**ADDENDUM NO. ONE (1)**

**PROJECT NO: 128696**  
**TITLE OF PROJECT: Flood Repairs**  
**FACILITY NAME: CF Dickinson Marine Laboratory**  
**LOCATION: Galveston County, Texas**

## AMENDMENT NUMBER 01

Amendment Dated 05/31/2018

**1 ELECTRICAL SITE PLAN**  
E101 1" = 20'-0"

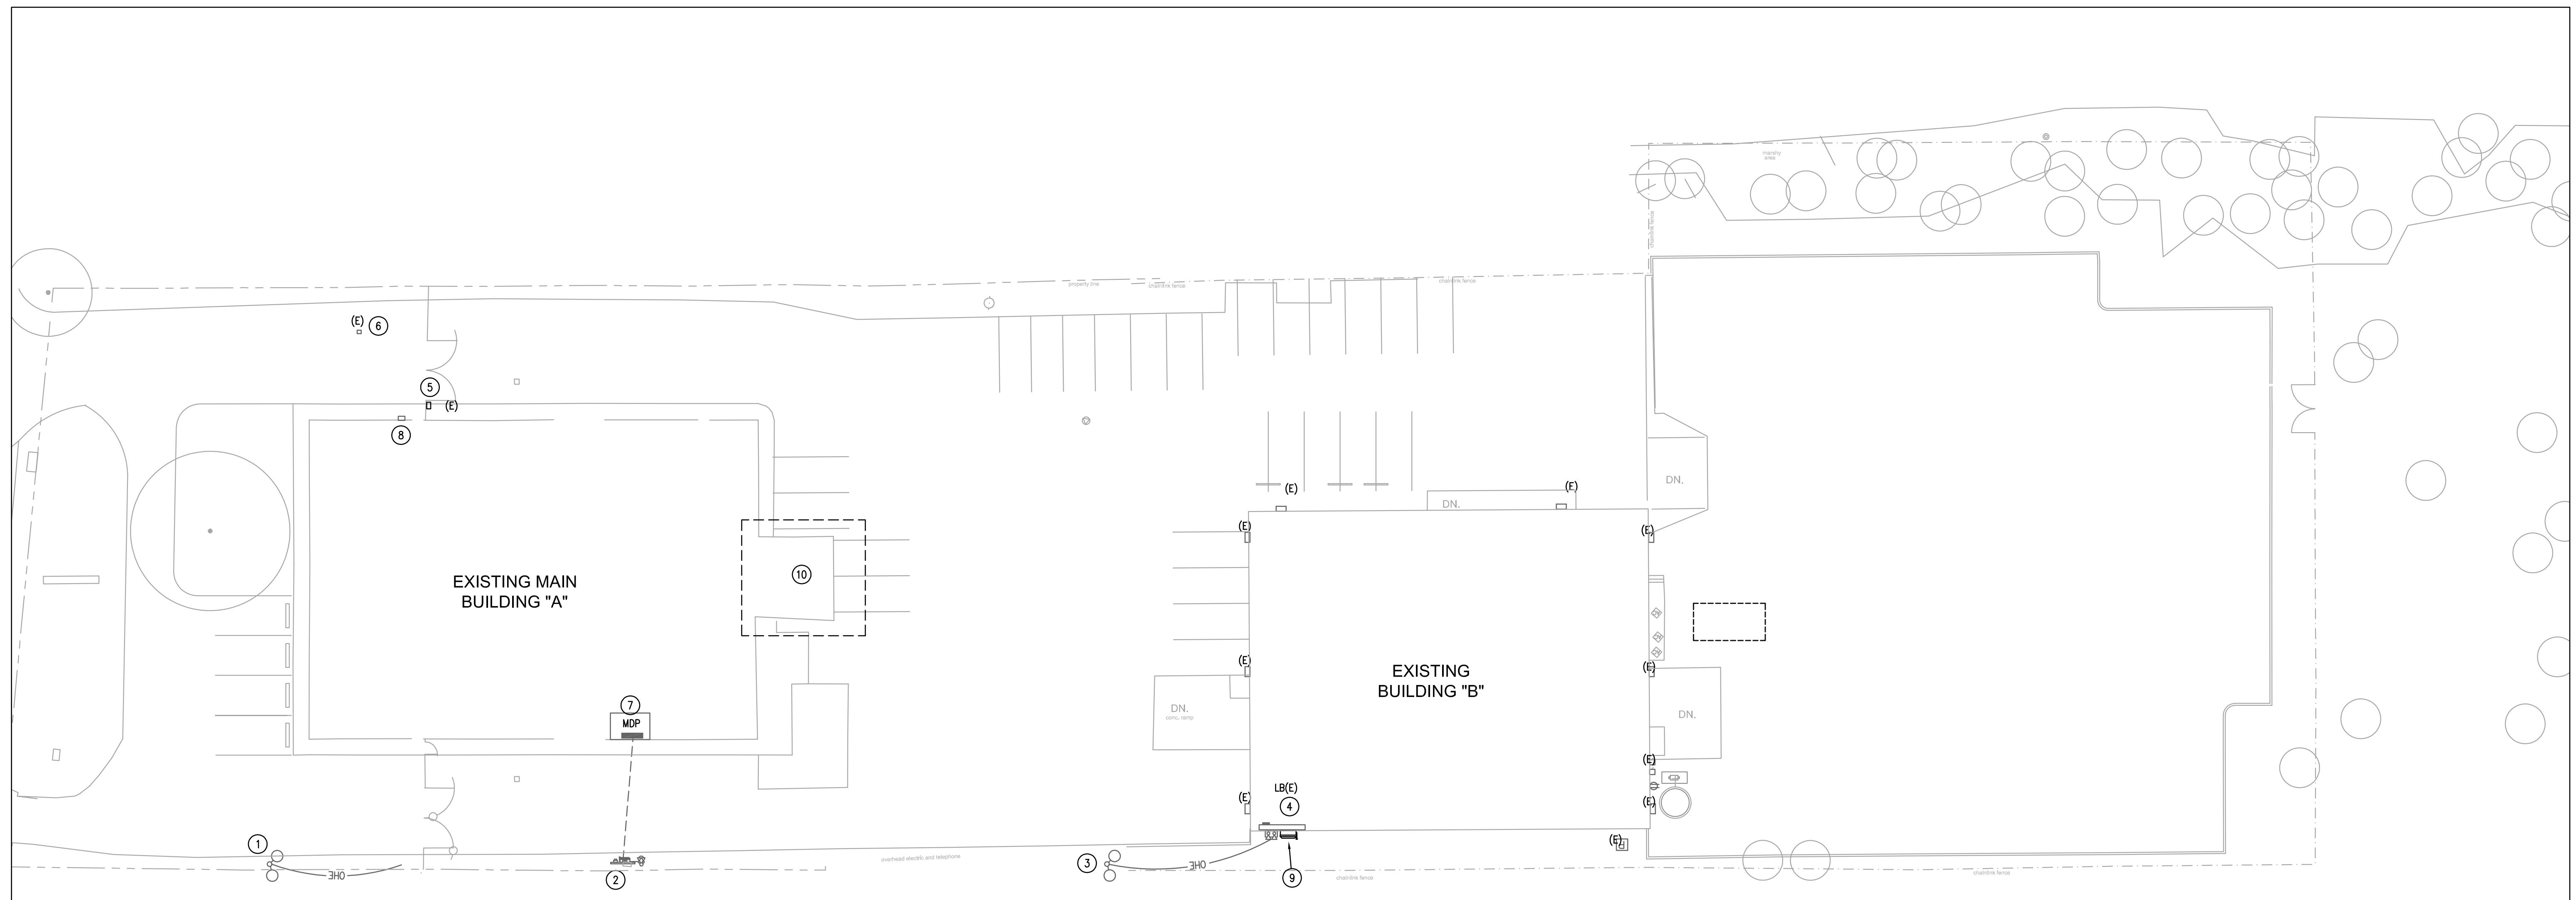
8. EXISTING "KNOX" BOX.
9. EXISTING 400A, NEMA-3R MAIN FUSED DISCONNECT SWITCH TO BE DISCONNECTED AND REPLACED. REFER TO ONE LINE DIAGRAM #1/E3.02.
10. REFER TO THE ARCHITECTURAL DRAWINGS FOR BUILDING DEMOLITION IN THIS AREA. ELECTRICAL CONTRACTOR SHALL DISCONNECT AND REMOVE ALL EXISTING RECEPTACLES, LIGHTING FIXTURES, LIGHT CONTROLS, FIRE ALARM DEVICES, DATA/COMM PLATES ETC. IN THE AREA OF BUILDING DEMOLITION. REMOVE CONDUIT AND WIRE BACK TO POINT OF SOURCE. MAINTAIN CIRCUIT CONTINUITY TO REMAINING RECEPTACLES, LIGHTS, DEVICES.
